SDE Upgrade

WP5 ECRs

ECRs (Dec 2018) for the next UUB version 3

ECR 5, 17, 19 & 29: 120 MHz clock 1/2

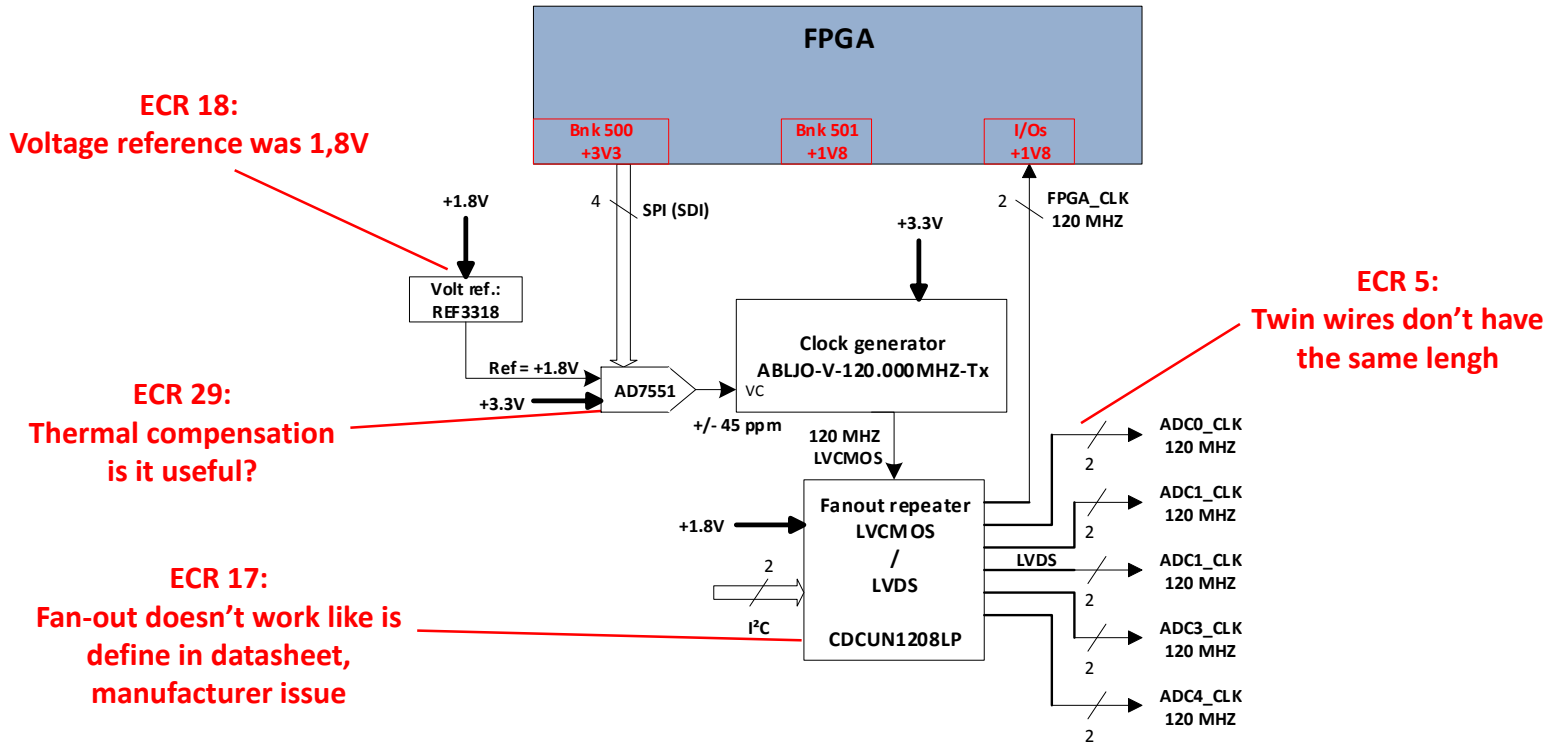
Present V2.0 Schematic:

The Fan-out component must be changed. It is not conform to the manufacturer specification

ECR 5, 17, 19 & 29: 120 MHz clock 2/2

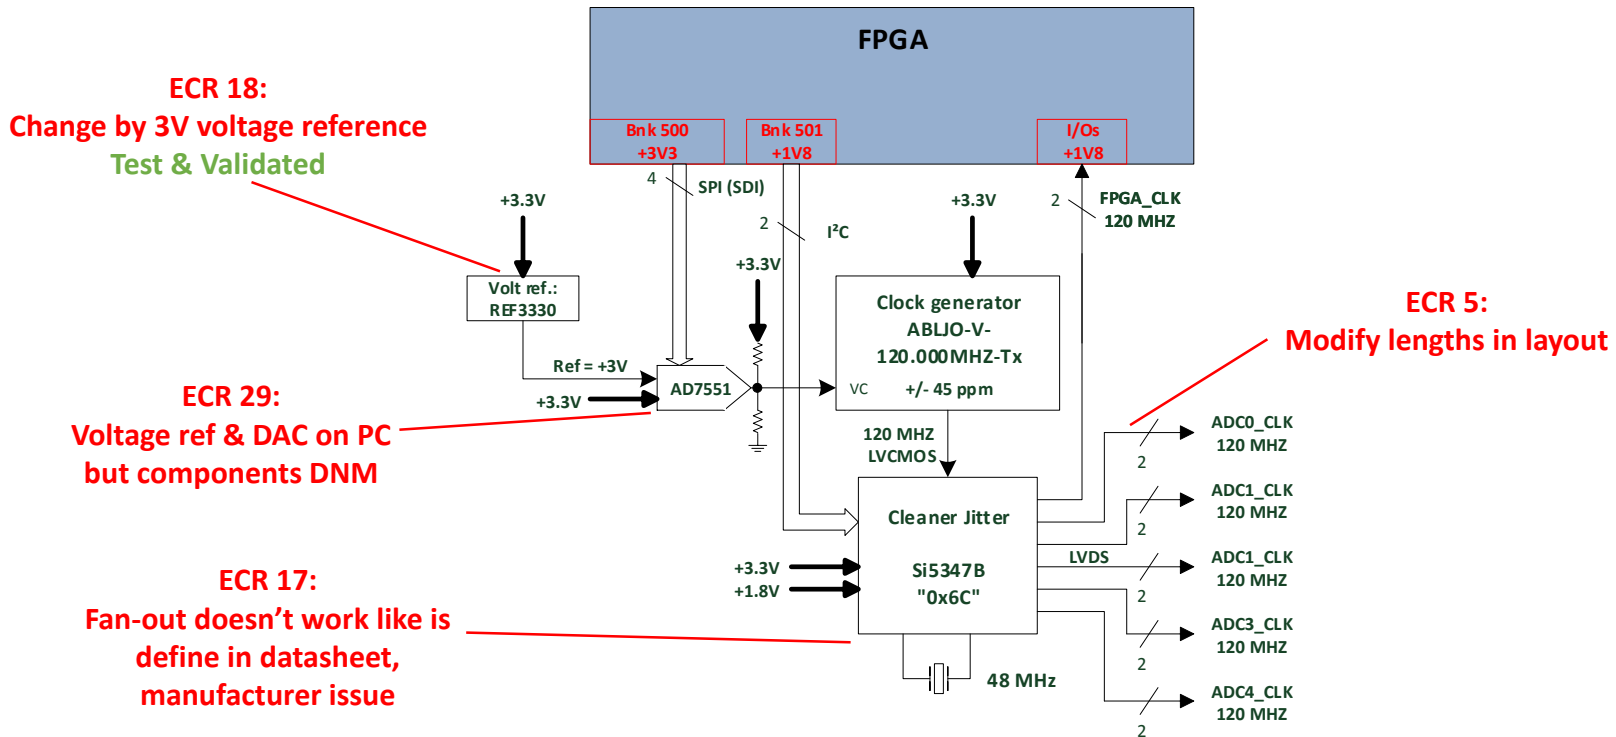
Next V3.0 Schematic:

- The Fan-out is changed by a solution already test and validated: **Jitter Cleaner**
- Thermal frequency compensation useless: Time tagging function already integrated -/+ 45ppm tolerance

ECR 4, 38 & 46 : FPGA protection

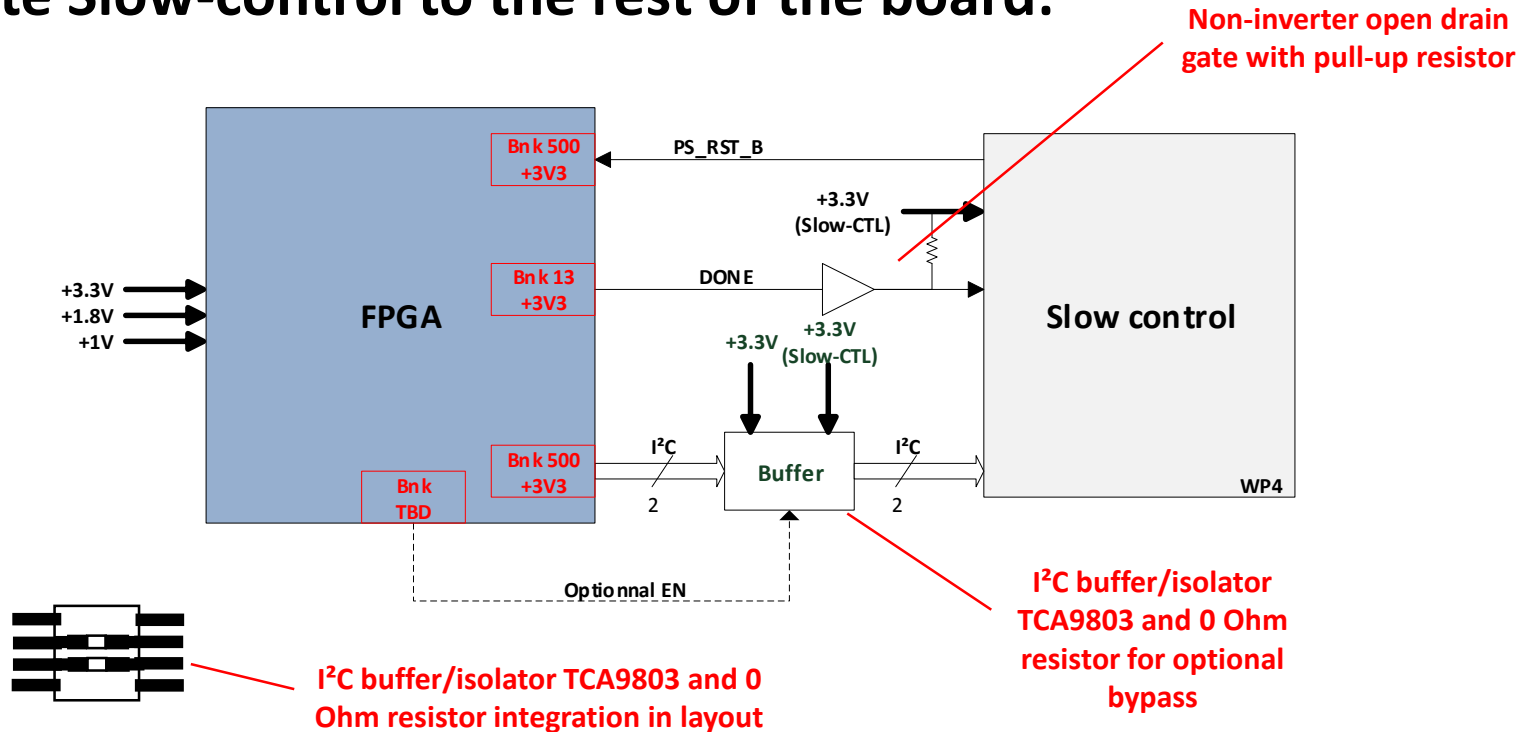
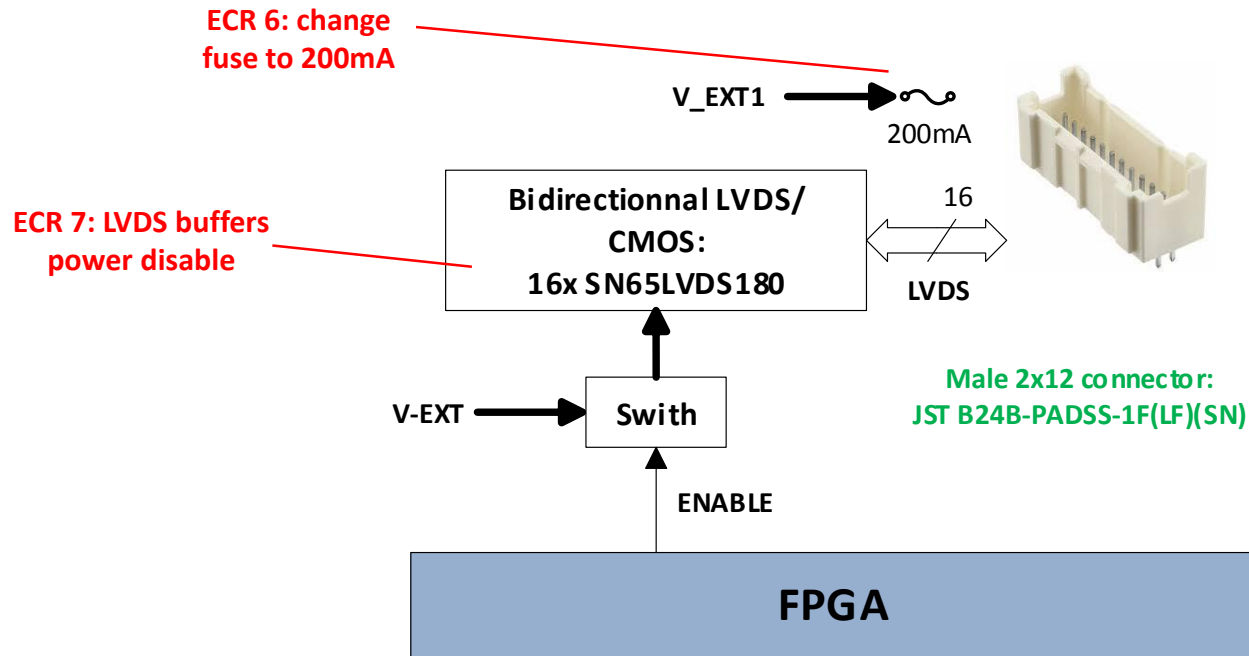
Isolate Slow-control to the rest of the board:

The slow-control starts the first and send voltage to FPGA when it isn't powered:

Dangerous for FPGA

ECR 11, 47 & 48: UUB EMC noise

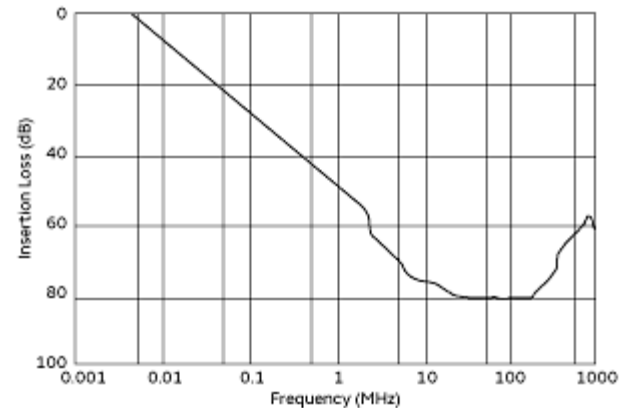
Noise is generated by UUB and transmitted by the cable

- The 24 Volts provided by UUB on digital connectors should also be filtered. These connectors will power external devices
- External cables should be shielded. They transmit the noise everywhere

A EMI filter will be added after the main UUB power connector:

ECR 20 : FPGA frozen when no USB PC connected 1/2

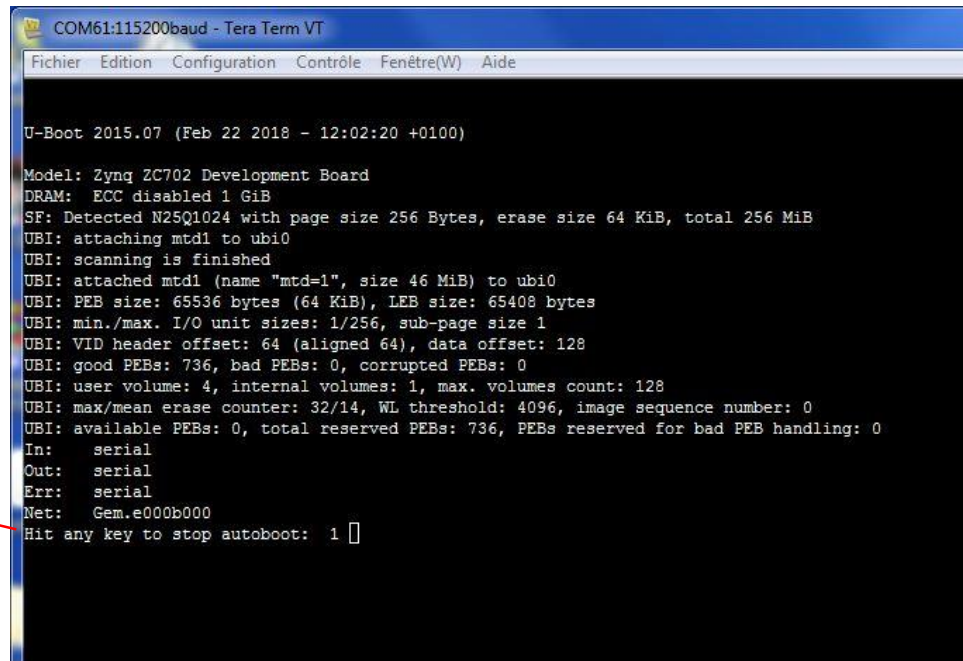
- Several hardware solutions (v1 & v2 schematic, added buffer, ...) was tested, but no one solve this issue for all boards.

Tested with V2 hardware schematic and a specific software where the U-BOOT can't be interrupted: the issue is solved

Software update and MAC address could be made with Peta-Linux

ECR 20 : FPGA frozen when no USB PC connected 2/2

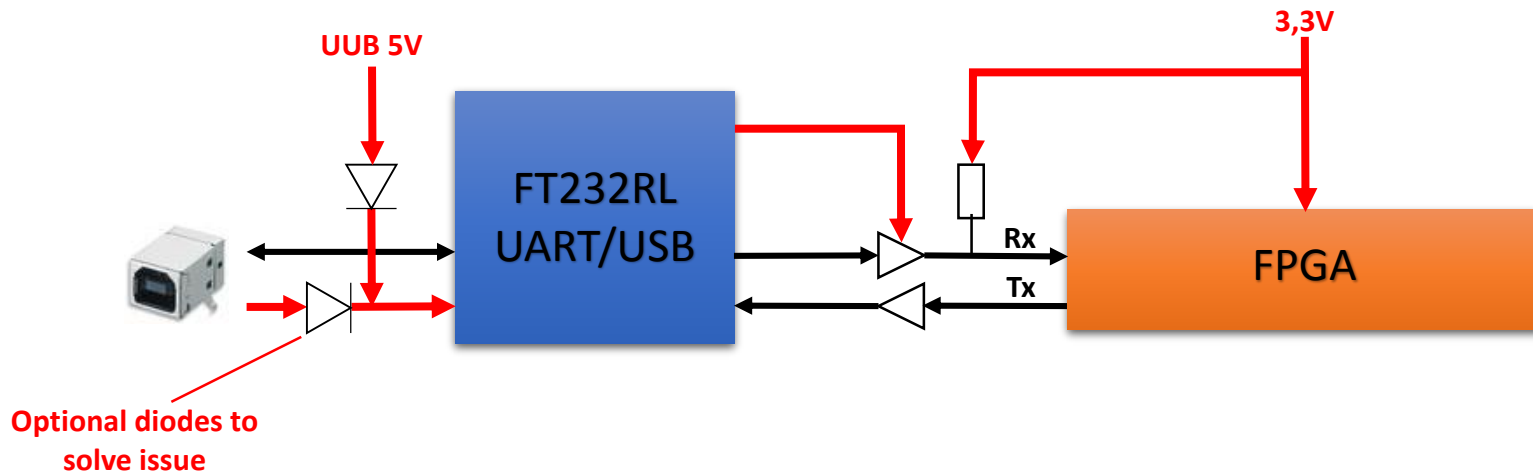
- The FPGA must have protection against external voltage from USB interface

Buffer open-drain must be added for FPGA protection. VCCIO pin powered by UUB 3,3V, it's not enough.

ECR 26: TRACO DC/DC modification

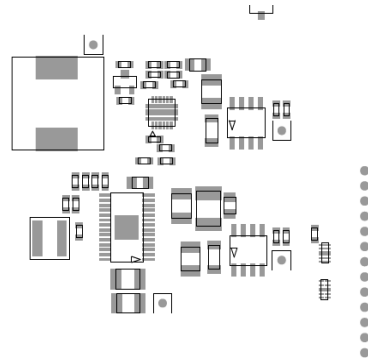
They are too noisy. But the Enable function works.

Less noisy but up to now a relay is used for Enable/Disable function. It could generate problem, like spike in channel 9.

If it is possible, the Relay should be changed by a new electronic: **In work**

ECR 35: Programmed component

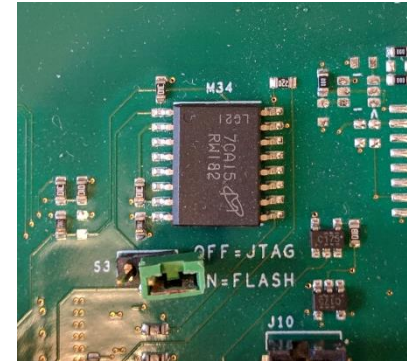
Slow-control μ C & Flash Memory:

Slow-control μ C:

- Programmed by manufacturer
- Optional package reference

Flash Memory:

- Programmed and repackaged by a subcontractor

Min 21 weeks lead time

Final software for Slow-control must be provide early

NO SOFTWARE UPDATE DURING MASS PRODUCTION AT SUBCONTRACTOR

ECR 40: Spikes on channel 9

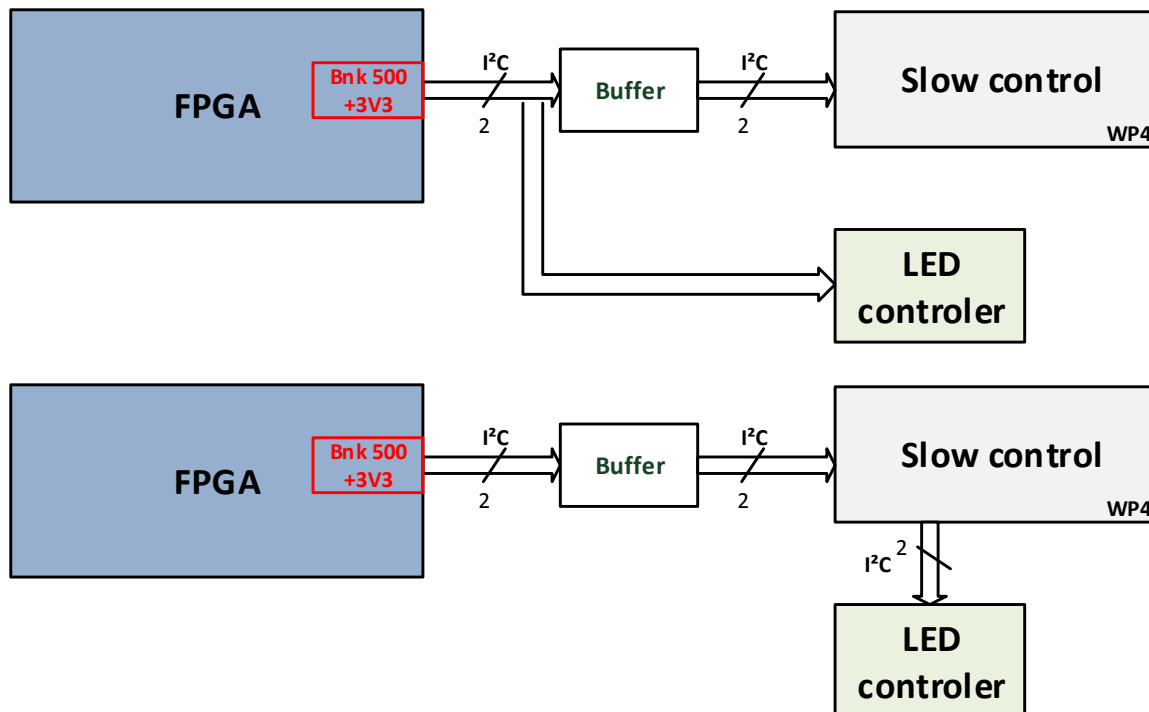
Present -/+ 3,3V DC/DC:

Spikes come from DC/DC Position. They are on the back, with their internal coil close UUB PCB.

Relay doesn't generate spikes
